# Recall Campaign

February 2016  
FL697A-E  
NHTSA #15V-842  
Transport Canada #15-015

## Subject: TBB Spectal Pushout Windows

**Models Affected:** Specific Saf-T-Liner C2 model vehicles manufactured May 1, 2015, through August 1, 2015, with certain Spectal tempered glass pushout windows.

**Figure 5: Testing the Viscosity of the Glue**

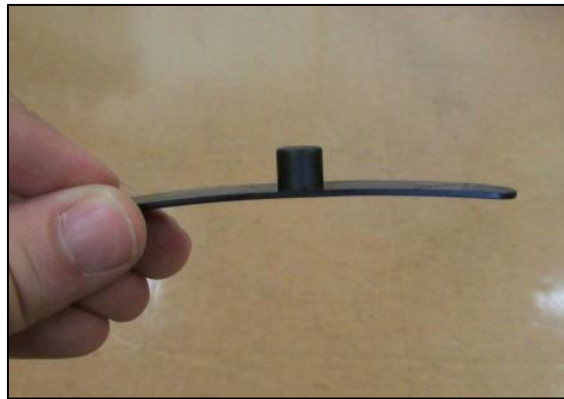
6. Once the glue is inserted, make sure the viscosity of the glue is correct. Turn the slider retainer upside down. The glue should not drip out of the cavity. See **Figure 5**. If it does, use the other recommended glue shown in **Table 1**
